Modified anchorage parts for safety belts

Shackle 644,803,111,02 is being replaced by retaining bolt 644,803,122,00.

Fig. 7

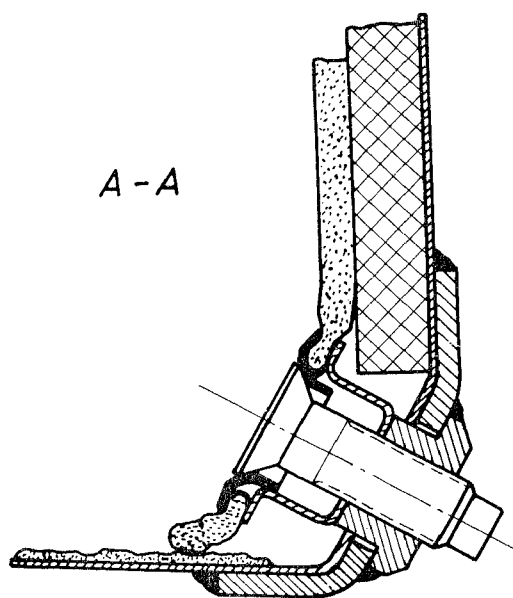
(However shackle 644,803,111,02 is still being used for subsequent installation into vehicles without anchorage points.)

Mounting retaining bolt:

Remove countersunk screw in A-A and screw in retaining bolt with spacer tube (see sketches).
